Sheet: /LDO/

Title: CANDrive32 ESC Dev. Board

Rev: Rel 0.91

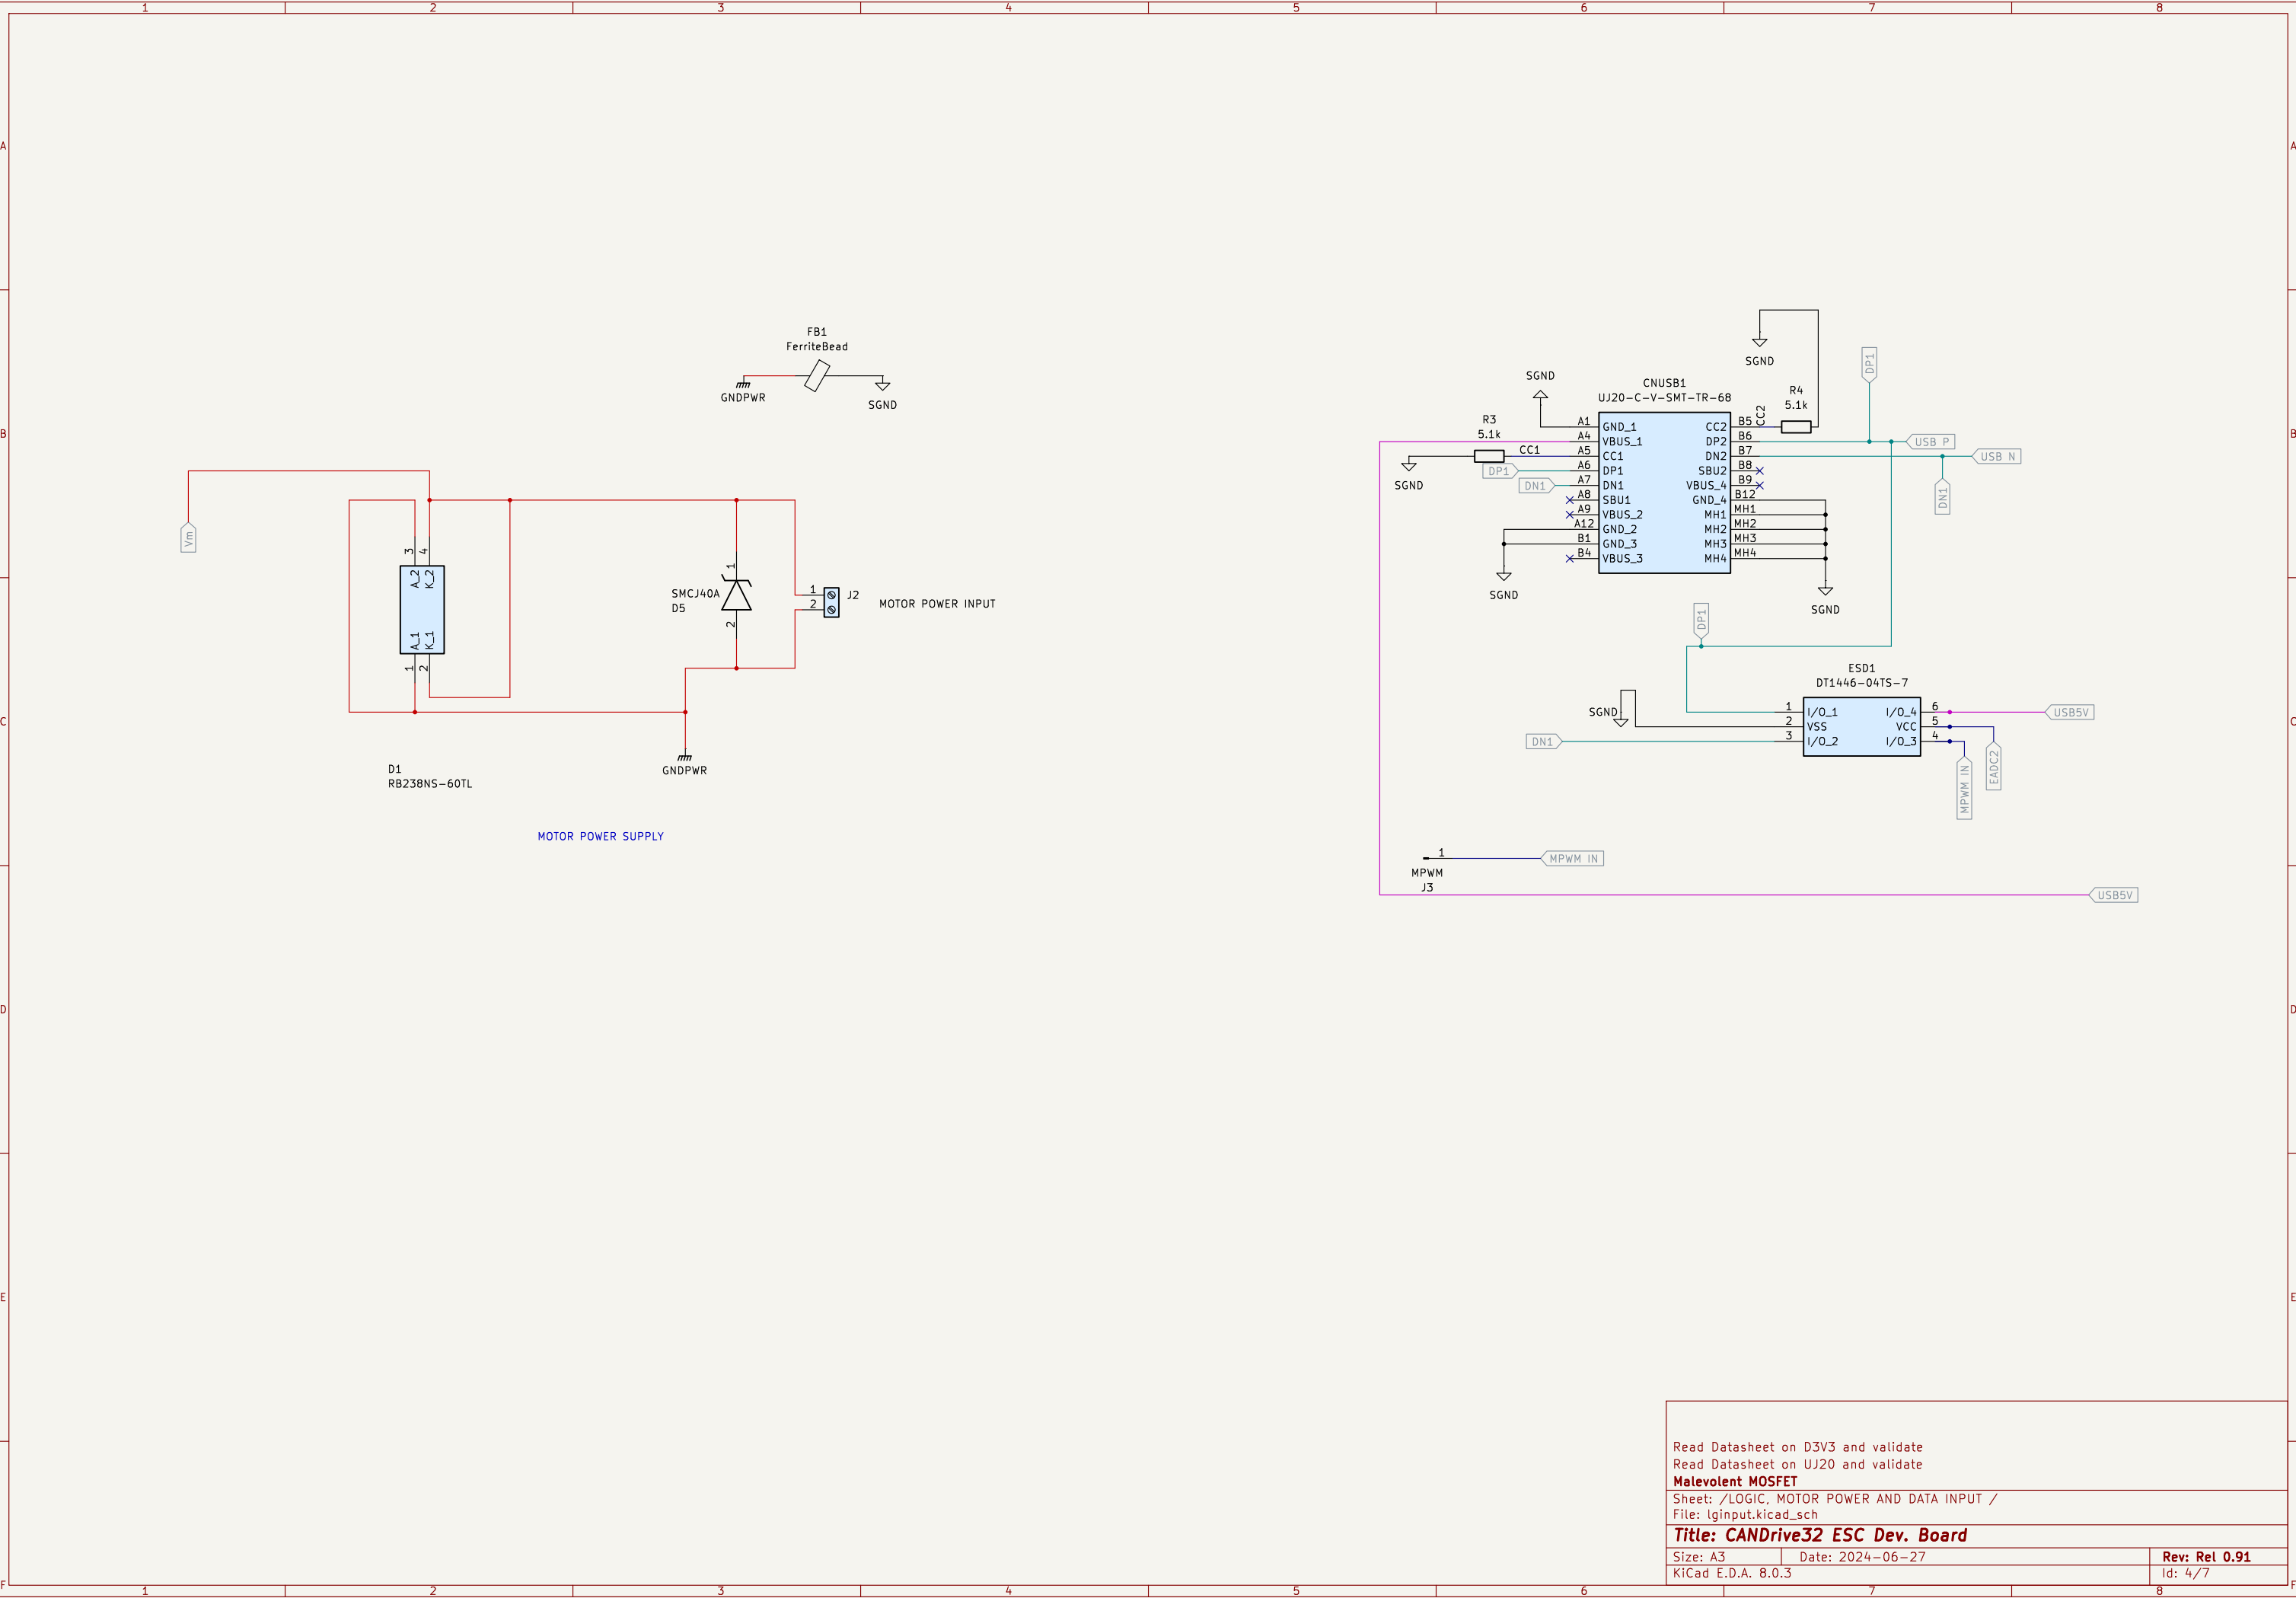
Does this design really need PG?

C8=Css, 5.6nF is 10ms of Soft Start Delay Check if OK for downstream

30th March: Set Output Resistors to 3.3V based on DS

Check EXP Pin

Sheet: /LOGIC, MOTOR POWER AND DATA INPUT /
File: lgInput.kicad_sch

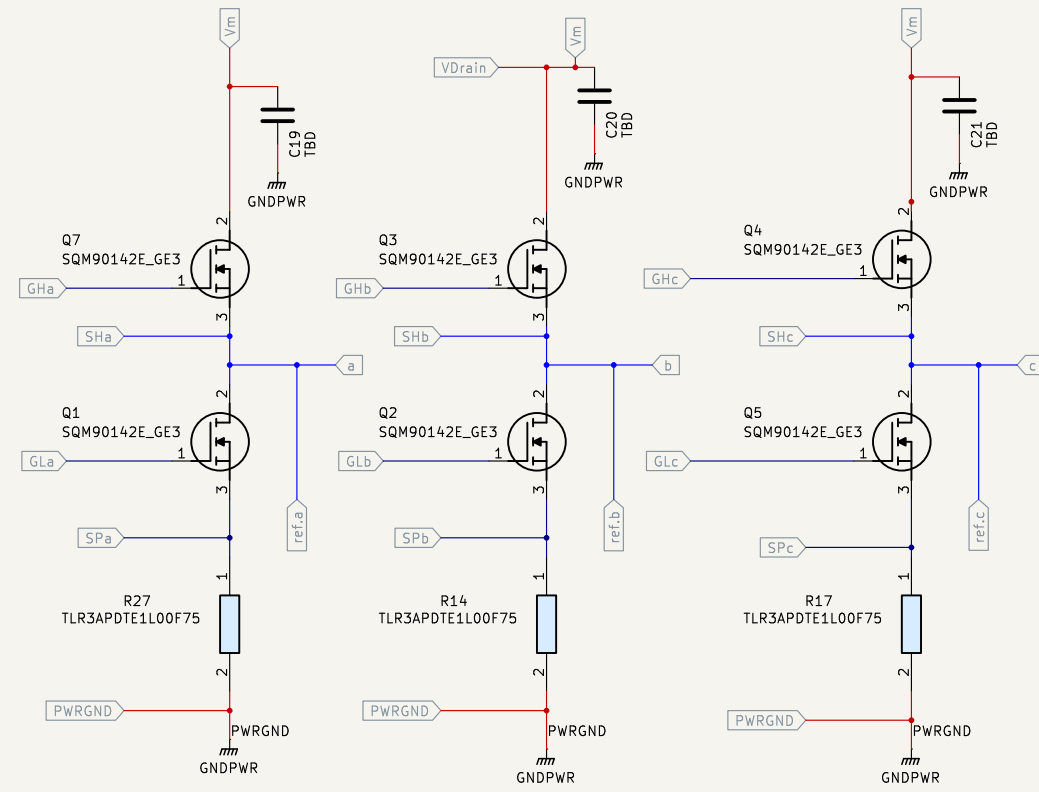
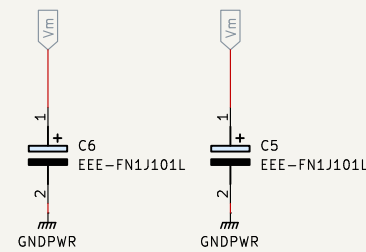
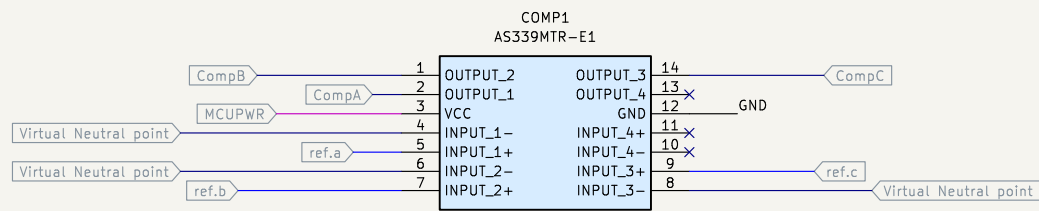
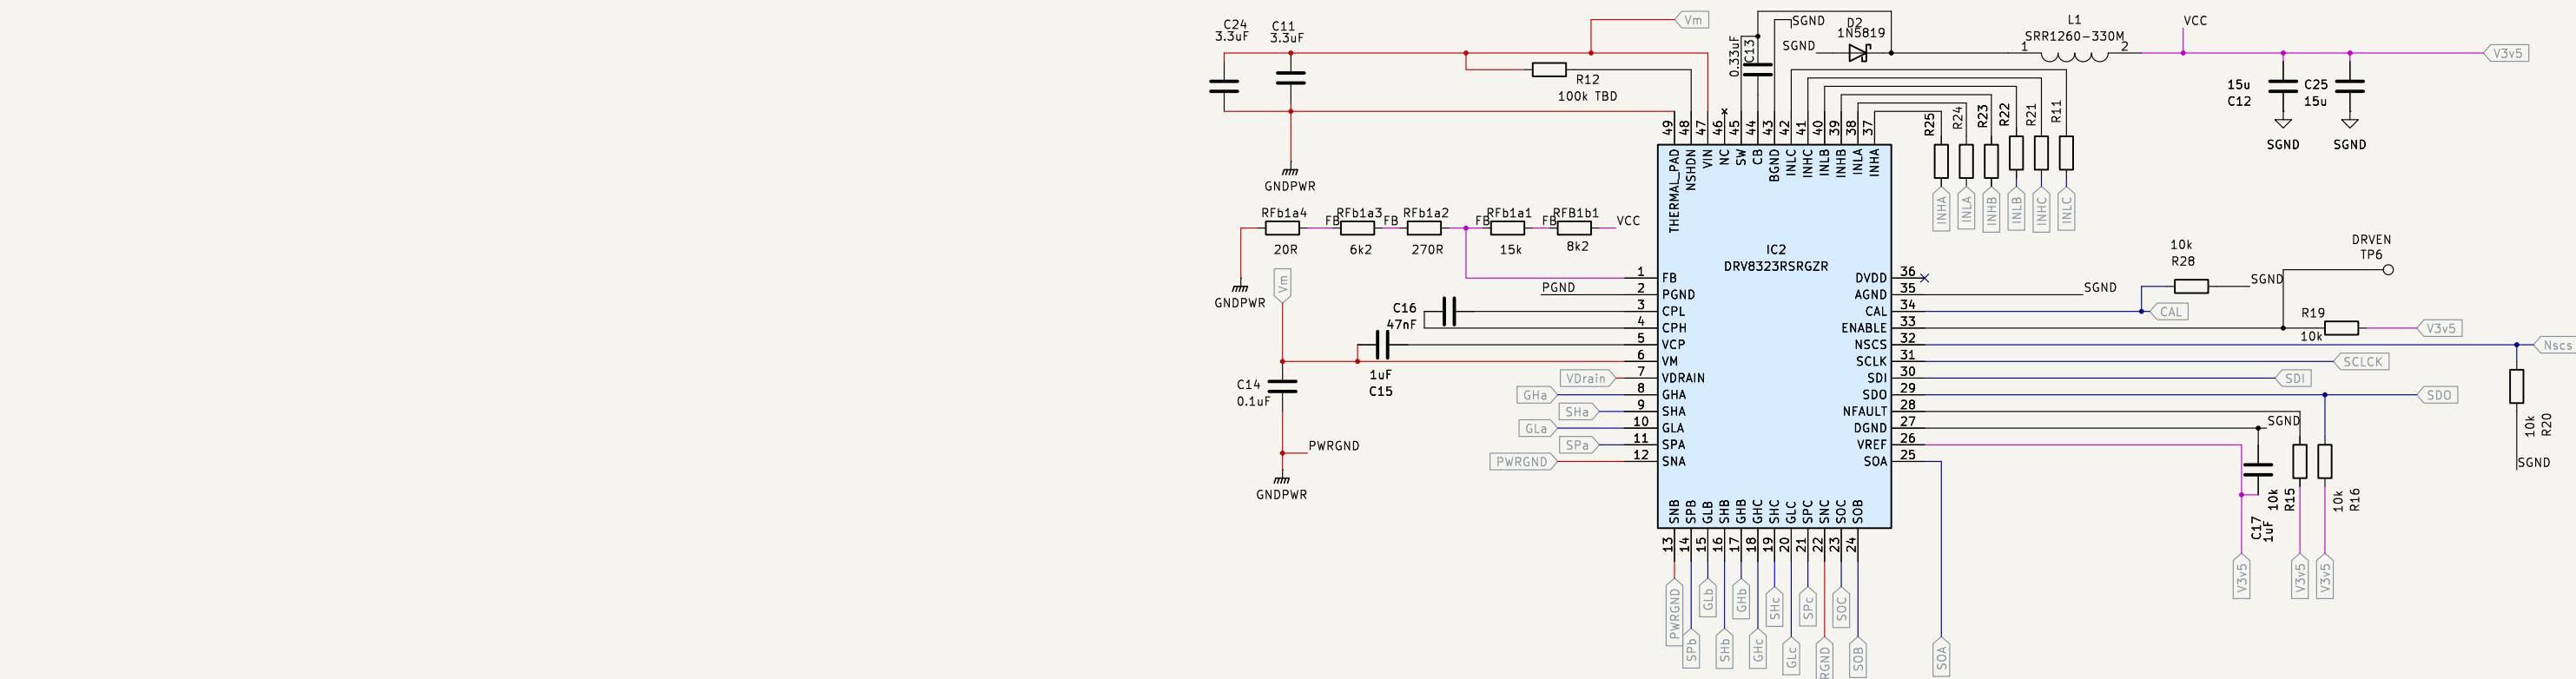
Read Datasheet on D3V3 and validate
Read Datasheet on UJ20 and validate
